Your ref
Y/186/21/PL

Our ref
DSA000007724

Proposal: Erection of 32 No dwellings with associated works including access, landscaping and parking. This application may affect the setting of a listed buildings, may affect the Main Road/Church Road Conservation Area. This application is in CIL Zone 2 and is CIL Liable as new dwellings.

Site: Y/186/21/PL: - Bonhams Field Main Road, Yapton, BN18 0DX.

ARUN DISTRICT COUNCIL Y/186/21/PL

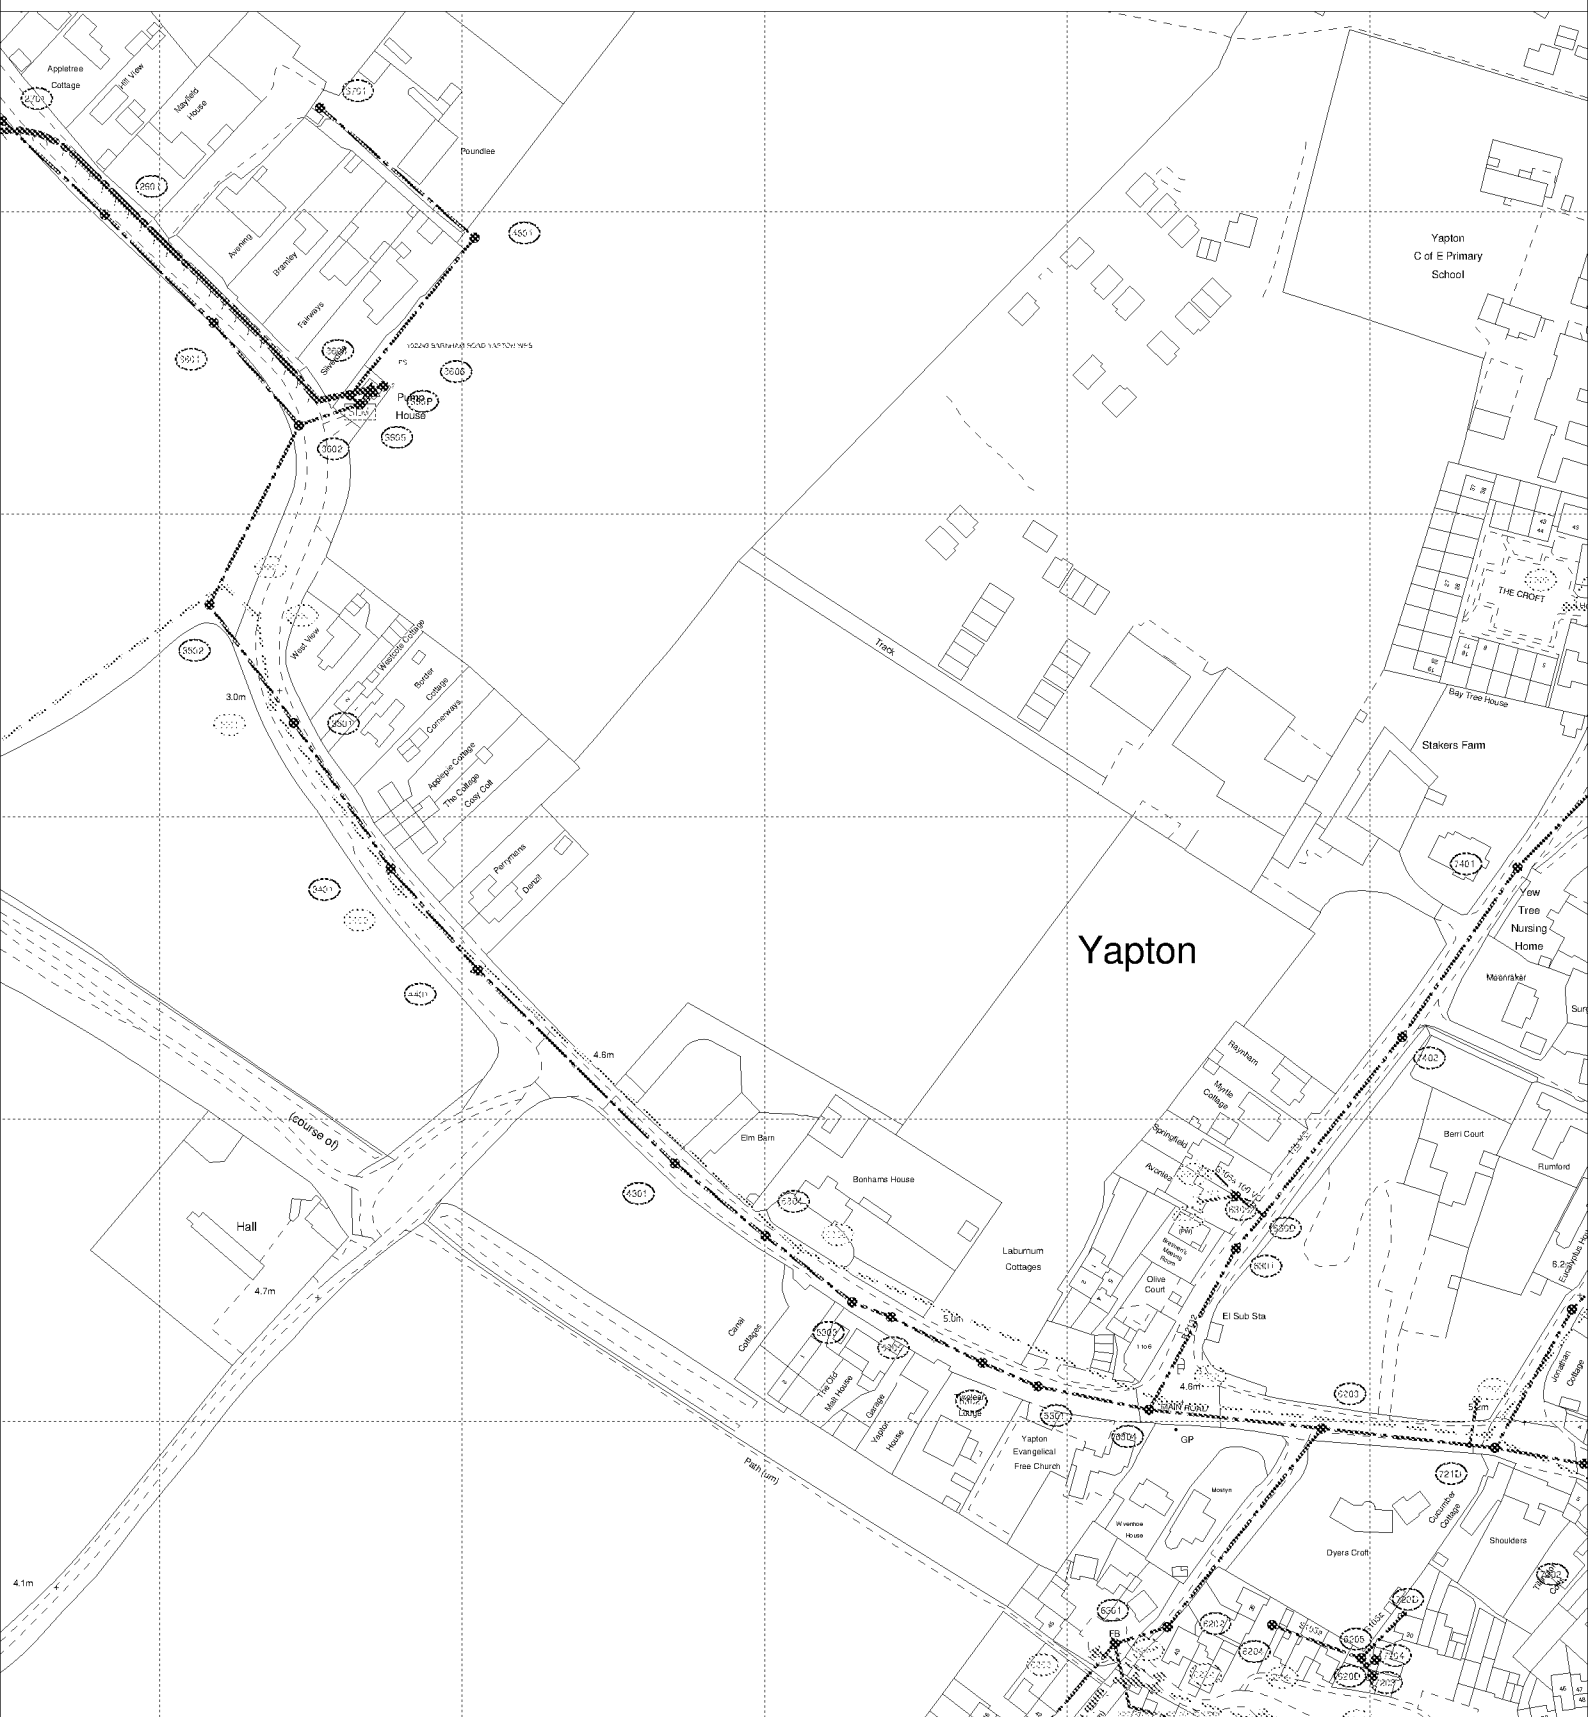
It is possible that a sewer now deemed to be public could be crossing the development site. Therefore, should any sewer be found during construction works, an investigation of the sewer will be required to ascertain its ownership before any further works commence on site.
